# Queensland Coke and Power Plant Project Environmental Impact Statement

**Supplement Report**

Environmental Impact Statement  
Supplement

29 June 2006

Figure: 3.1a

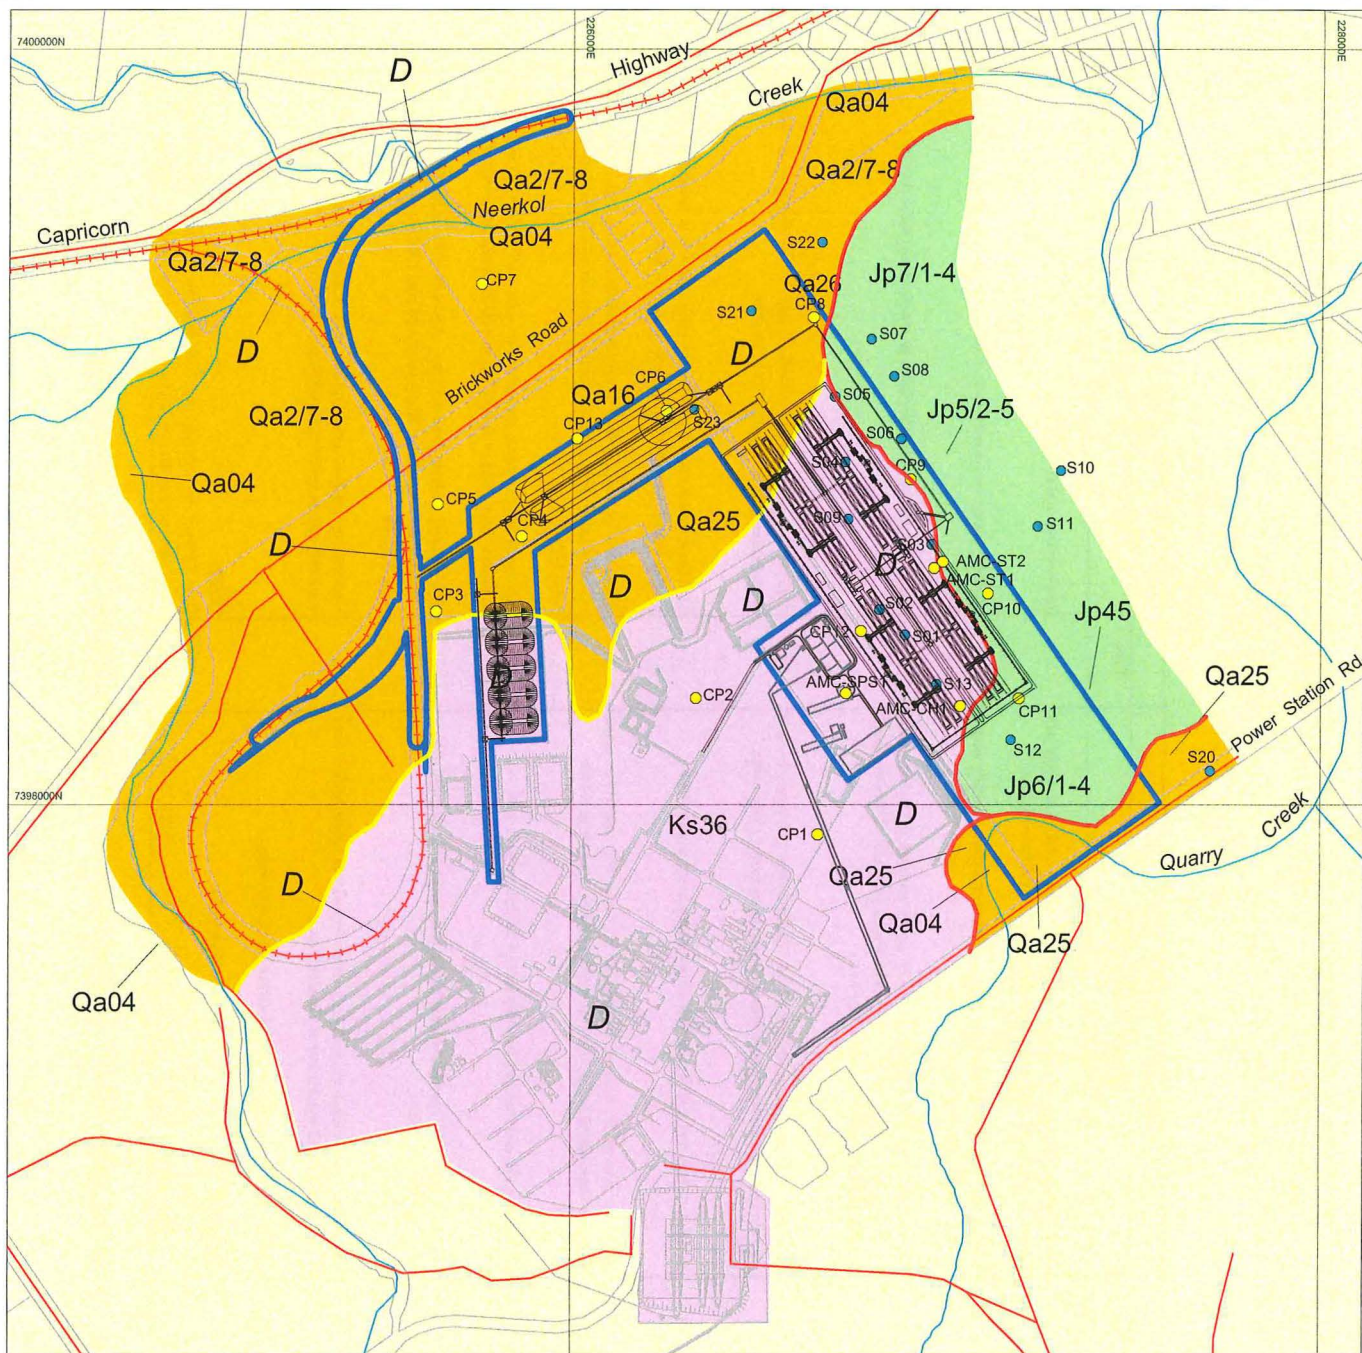
*DNRMW states that the limitations for alluvial Terrain Unit Qa2/7-8 with non-cracking and cracking alluvial clays in Appendix D.5 are only minor to moderate, indicating that it should be assessed as Class A, suitable for cropping, due to moderate erosion hazard, and not Class B. DNRMW has prepared an Agricultural Land Class map for Fitzroy Shire which has been used to delineate Good Quality Agricultural Land for the Fitzroy Shire Planning Scheme. The alluvial area along Neerkol Creek (i.e. the area of Terrain Unit Qa2/7-8) has been mapped by DNRMW as Class A1, suitable for rainfed cropping. Whether it is Class A or B, the area is assessed as Good Quality Agricultural Land. DNRMW states that, based on the soil description (Appendix D.1), the small area of Terrain Unit Qa26 should be assessed as Class C, suitable for grazing. A severe moisture limitation should be listed for this soil along with the moderate erosion limitation (Appendix D.5). These limitations would preclude rainfed cropping on this soil.*

EIS Appendix D has been reviewed in light of the DNRMW comments and is presented in the Supplement as Appendix B. Revised descriptions of soil types identified at each of the soil sampling locations (CP1-13) are included as Supplement Appendix B.1. The soil types associated with individual terrain units are described in Supplement Appendix B.2.

Figure: 5.1

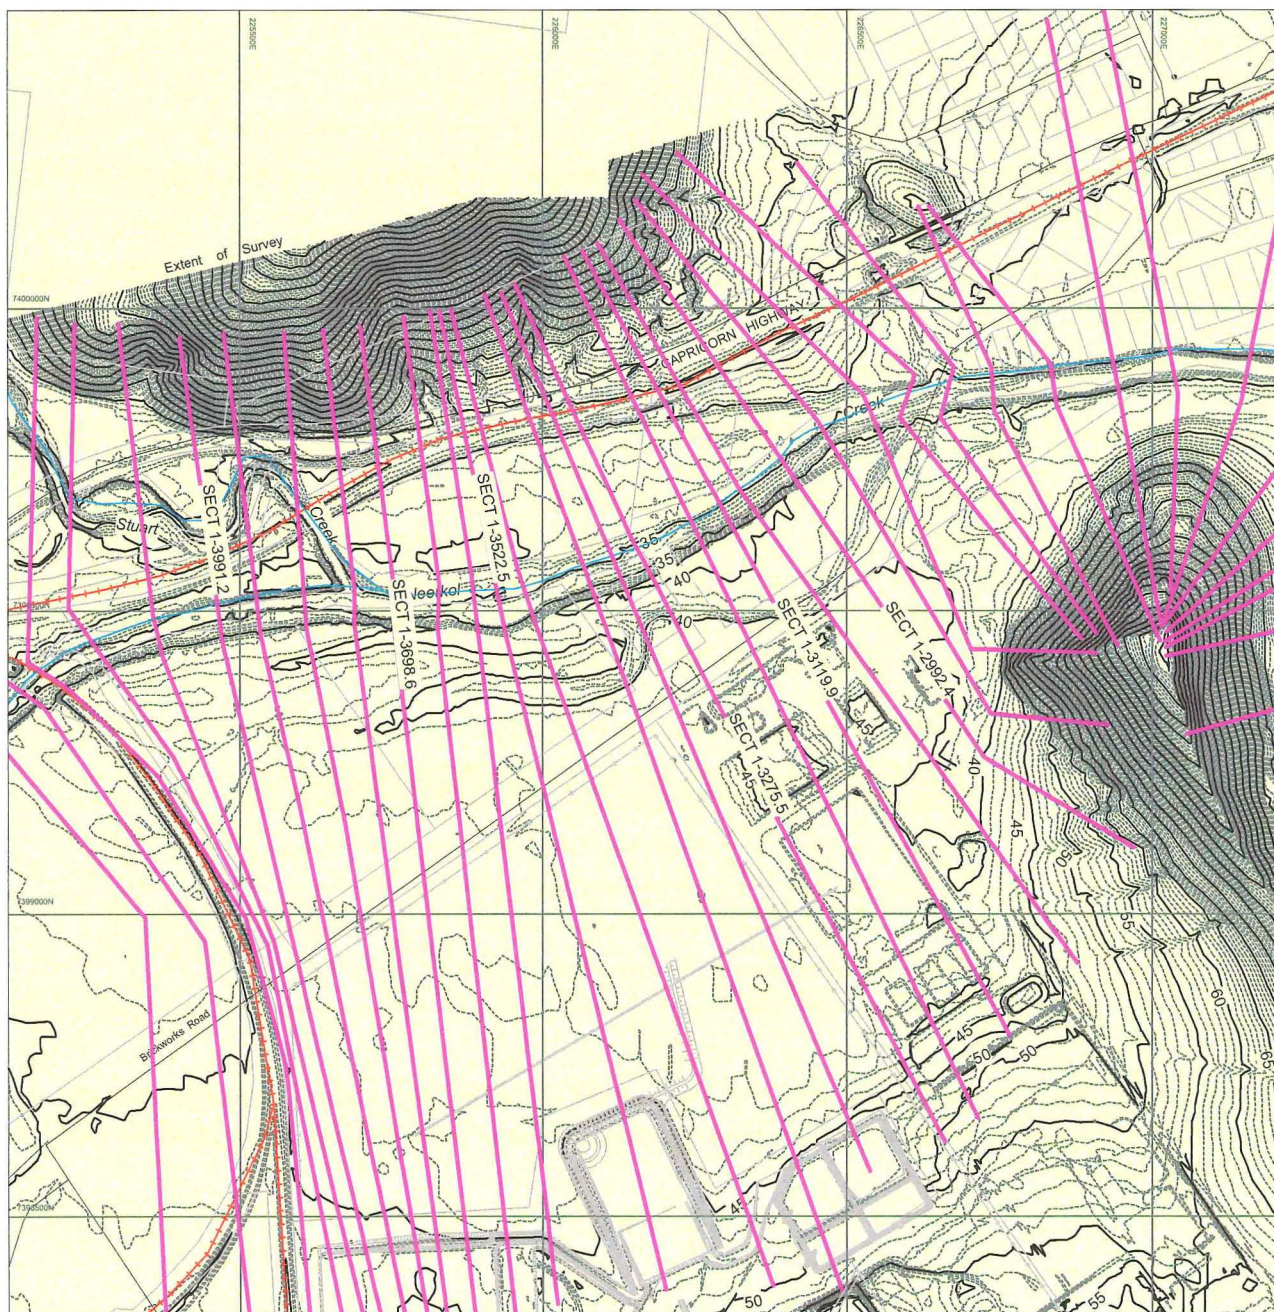
*DNRMW states that the proponent should provide a detailed assessment of the impact of any fill on the flood immunity of surrounding properties, upstream and downstream of the proposed development. The EIS should also demonstrate how the specific outcomes of State Planning Policy (SPP) 1/03 - Mitigating the Adverse Impacts of Flood, Bushfire and Landslide in relation to flooding will be met by the development. Figure 5.3 shows a substantial section of the rail spur and link will be affected by flood, however there is no discussion on this aspect in the EIS. DNRMW states that further discussion is required on how the effects of flooding will be mitigated.*

A hydraulic model was created using the current version of HEC-RAS (v3.1.3). Due to a lack of suitable calibration data or specific anecdotal evidence on the extents of flooding during known flood events the hydraulic model has been left uncalibrated. However, the parameters defined in the model have been developed from published sources and are based on URS' experience in rivers of this type. Cross sections for Neerkol Creek adjacent to the Stanwell project site were developed from contour data for the site and surrounding area and these were input to a steady-state model in HEC-RAS (Figure 5.1).
